CLIENT: SAVISTA DESIGN AND BUILD

PROJECT: POUND PLACE
ROUNDSTONE ROAD
ANGMERING

DRAWING TITLE: PROPOSED DRAINAGE LAYOUT
64 BED
SHEET 3

JOB NUMBER:	SCALE AT A1:	REV. STATUS:
SE1612	1:100	S4
DRAWING NUMBER:		REVISION:
PP-ISS-XX-XX-DR-C-3013		C07

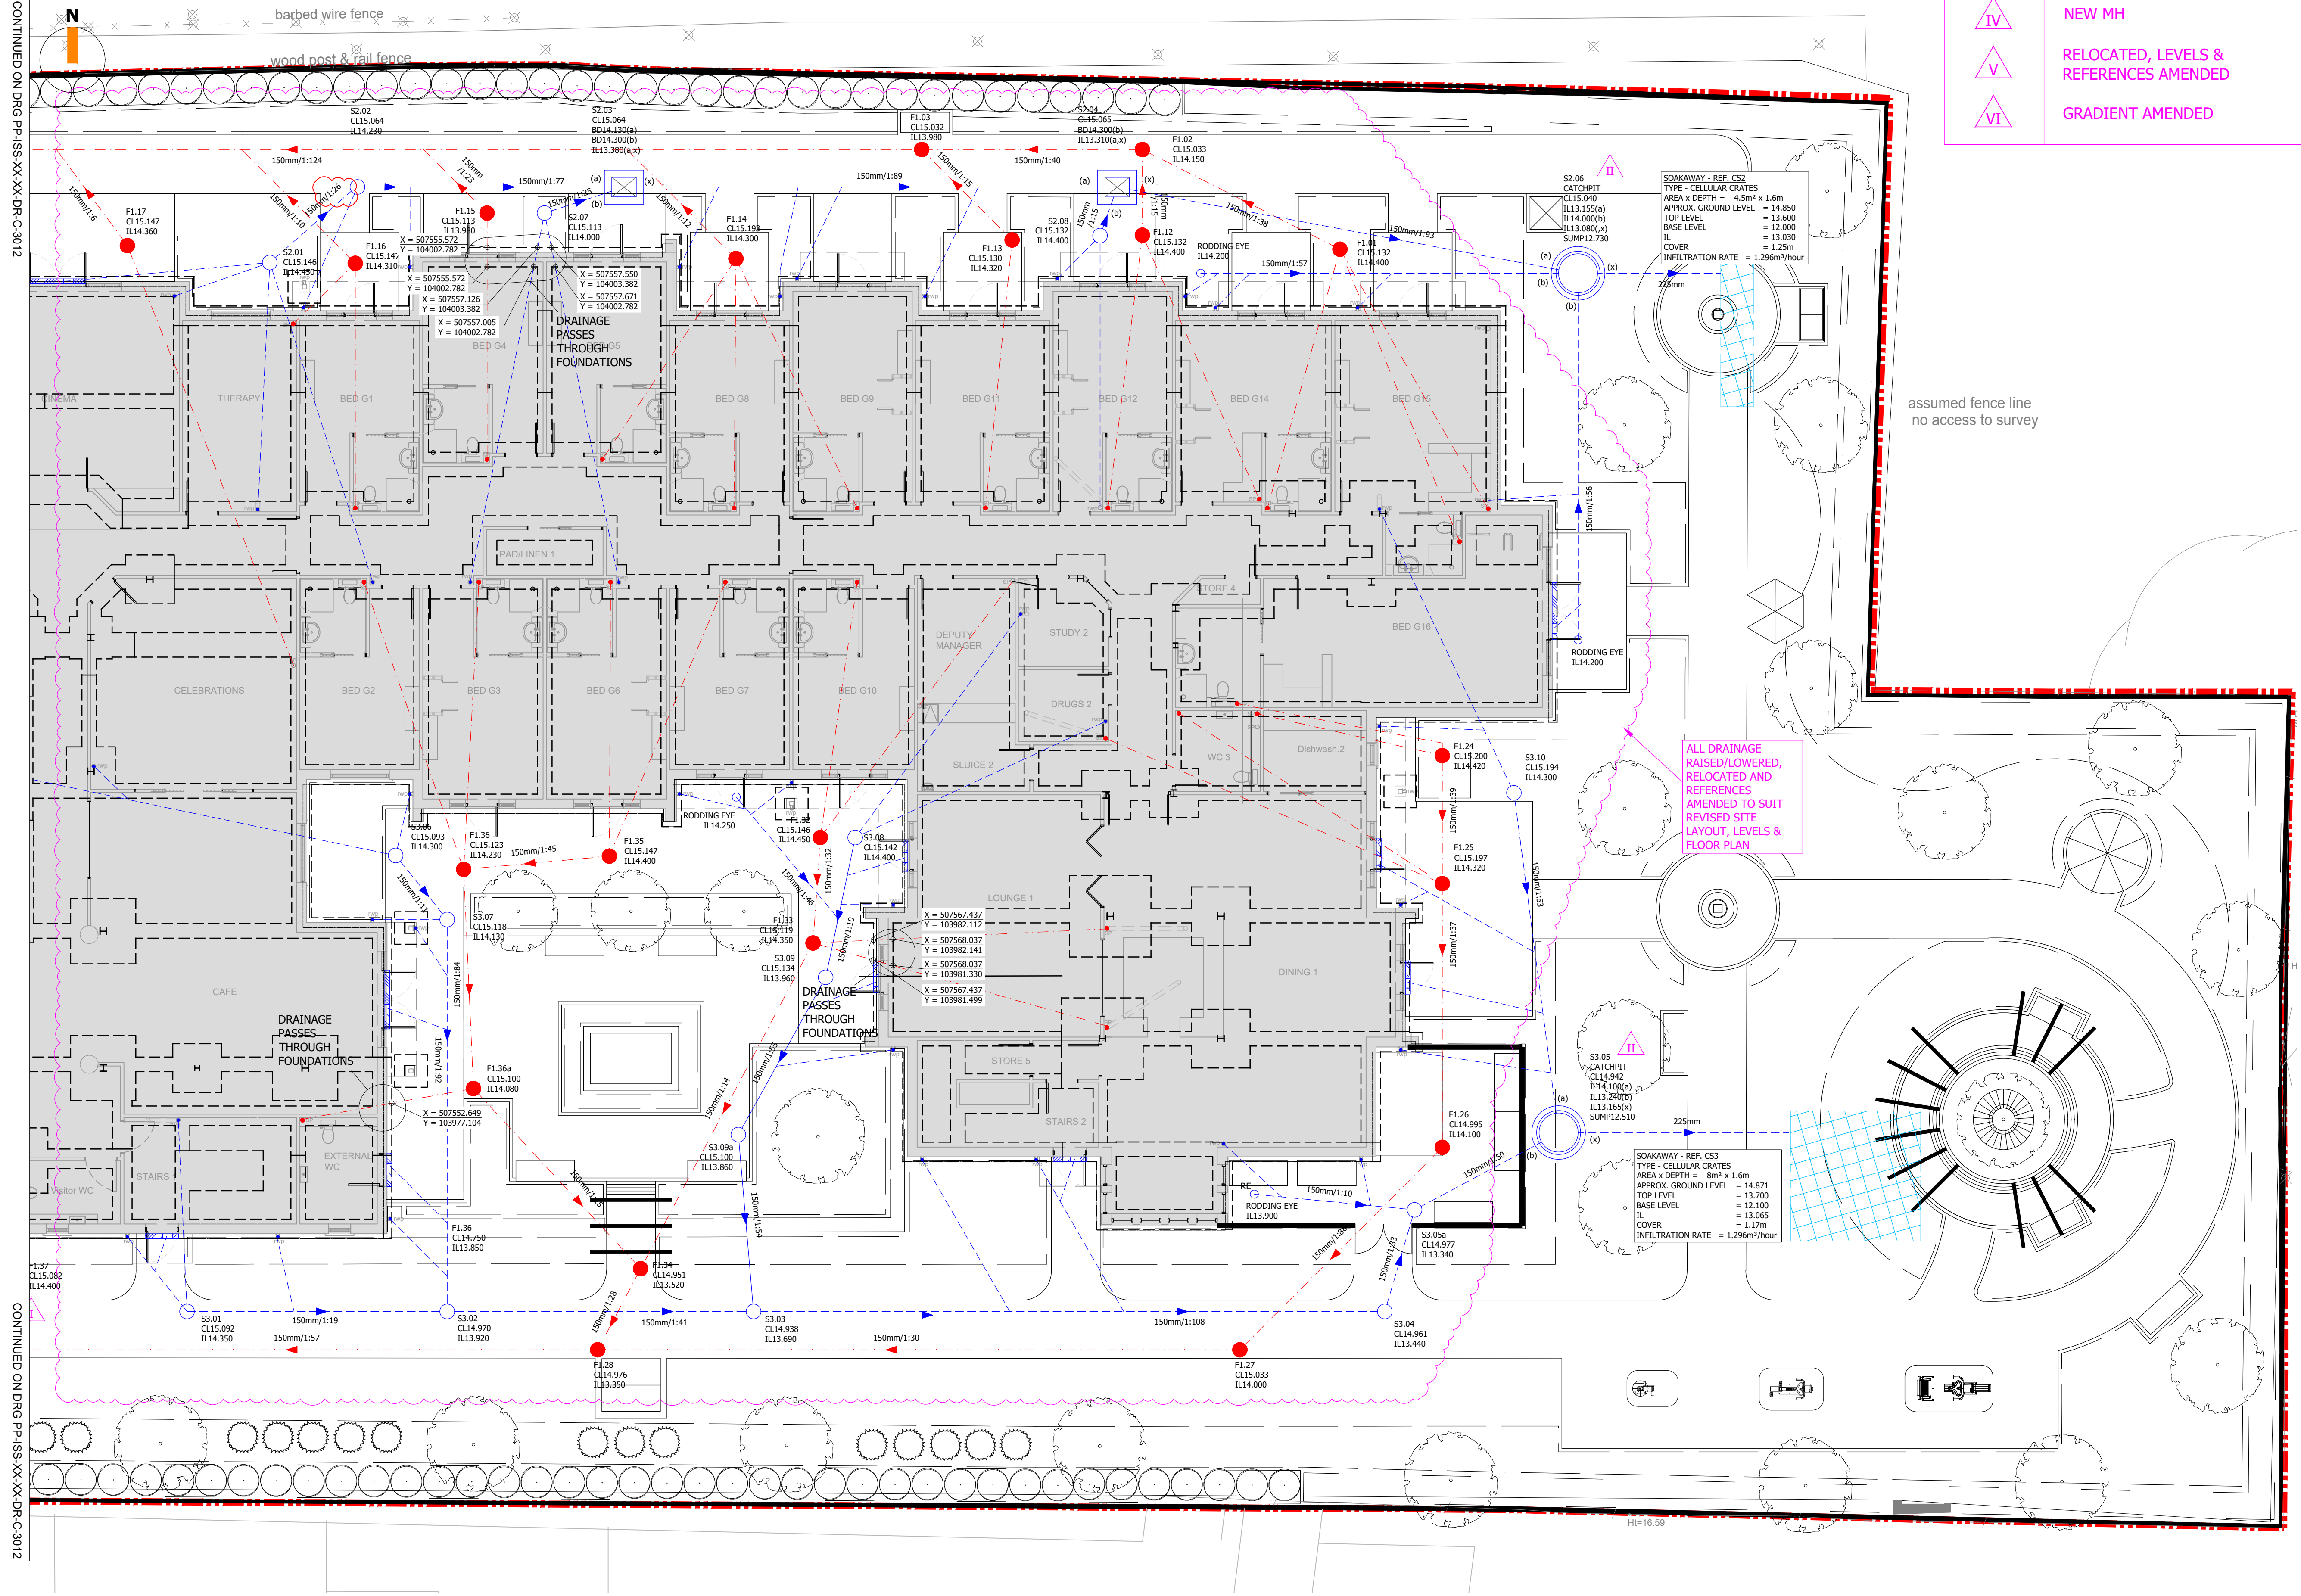
MANHOLE REFERENCES MARKED WITH "*" HAVE BEEN CONSTRUCTED BASED ON PROVIDED INFORMATION FROM THE CONTRACTOR ON 14.04.2020

DESIGN CHANGES FROM 62 BED SCHEME TO 64 BED SCHEME	
REFERENCE	CHANGES
I	REFERENCE, COVER + INVERT LEVELS AMENDED
II	COVER + INVERT LEVELS AMENDED
III	RELOCATED (LEVELS AMENDED)
IV	NEW MH
V	RELOCATED, LEVELS & REFERENCES AMENDED
VI	GRADIENT AMENDED
